Florida Keys Aqueduct Authority

RE: Turkey Point Units 6 and 7
Florida Power & Light (FPL) Nuclear Power Plant
Environmental Impact Statement (EIS)

**MIAMI-DADE COUNTY COMPLETENESS COMMENTS FOR
FPL SITE CERTIFICATION APPLICATION - TURKEY POINT UNITS 6 and 7**

DRAWING TITLE
 Surface Water / Salt Intrusion
 Source Map

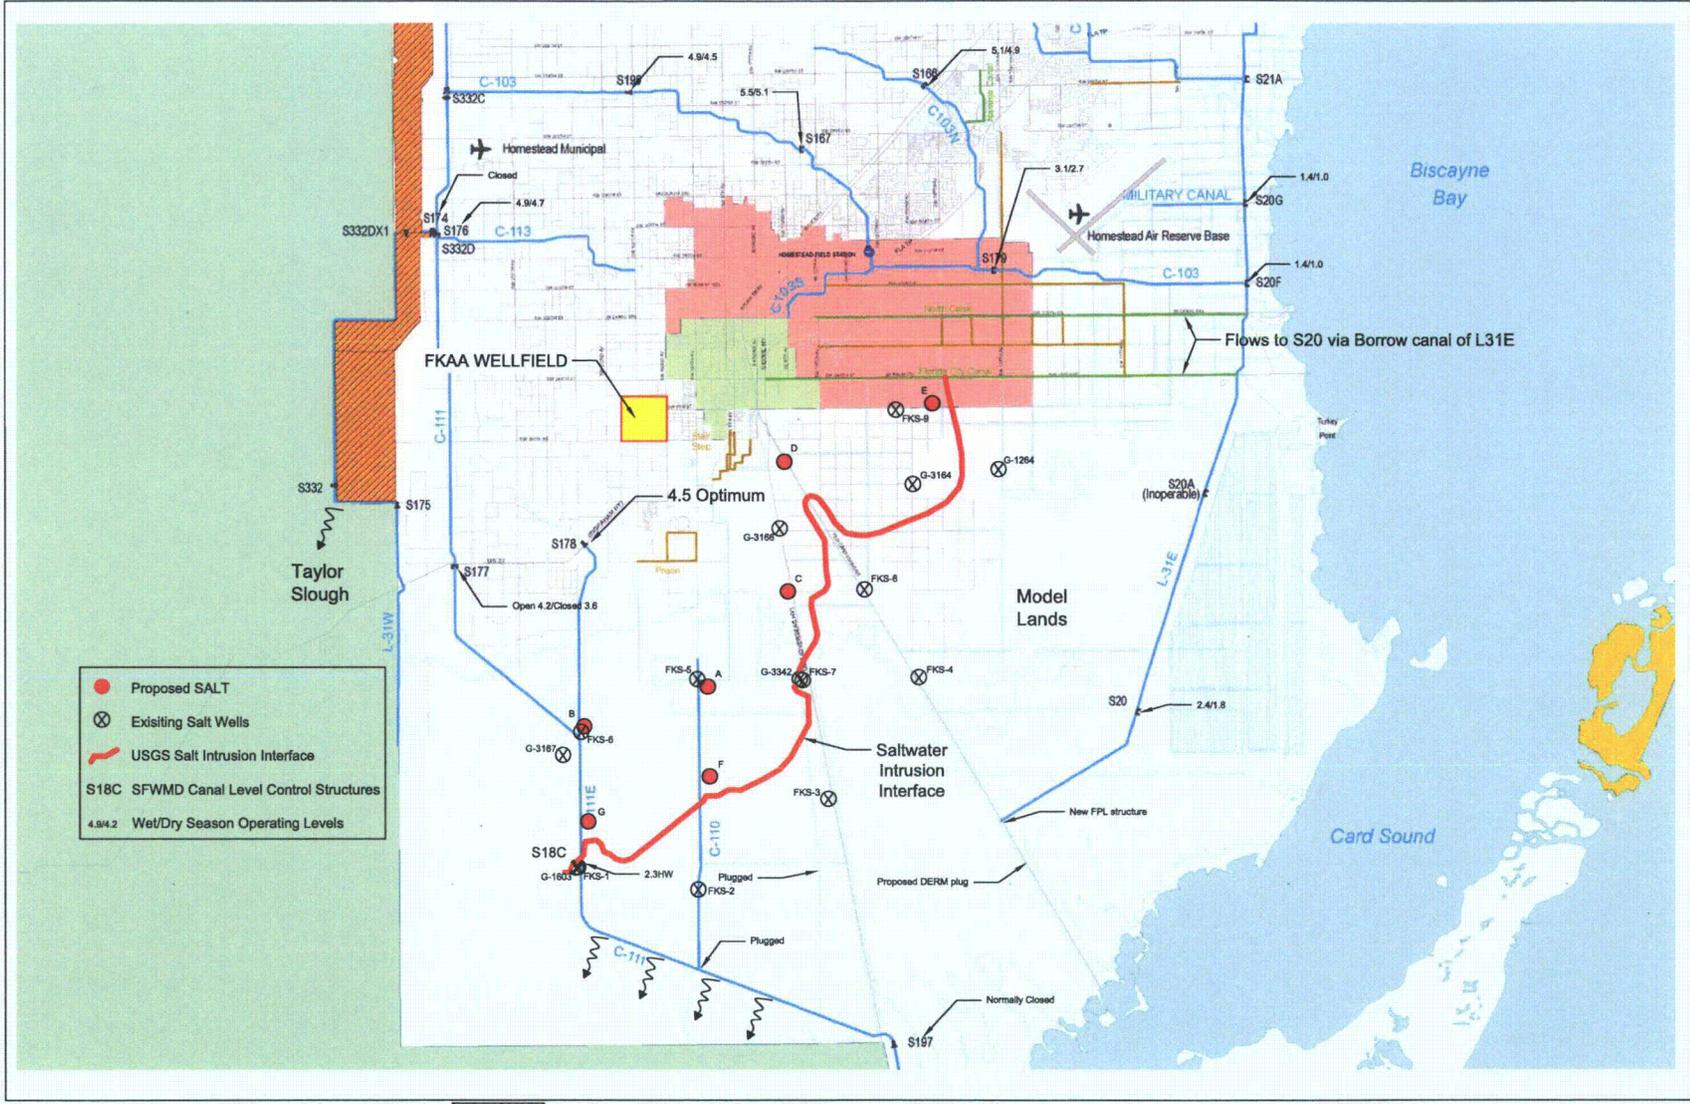
As an agency with responsibility to provide our customers with a clean and sustainable fresh water supply for Monroe County which is surrounded by seawater, we have concerns for any potential impacts to our water supply. As the proposed project is significant in size and nature, conducting a comprehensive EIS to address key concerns and impacts to the natural resources is a necessary part of the evaluation process. It is our understanding that FPL's existing cooling water canal system, located west and south of the power plant contains high salinity concentrations. This high salinity is derived from evaporation of natural sea water discharged within these cooling water canals. As the highly concentrated seawater enters the groundwater along the bottom and the sides of the canals, the receiving groundwater becomes more saline. Without adequately operating system controls, this hydrogeological process can continue with a resultant salt load into a fresher groundwater aquifer. The higher saline groundwater with a higher specific gravity can increase the rate and amount of salt water intrusion from east to west in the Biscayne Aquifer and toward the FKAA wellfield.

1. The FKAA requests that additional ground water modeling and monitoring be presented at the current salt/fresh water interface of the Biscayne Aquifer. As you see in the attached ground water monitoring plan, a trend has been shown and interface presented in collaboration with the USGS and Miami-Dade County to demonstrate the current interface location and its movement. For the EIS, modeling of potential changes to the interface position of this salt/fresh interface resulting from the proposed impacts from the construction and operation of the facility is requested.
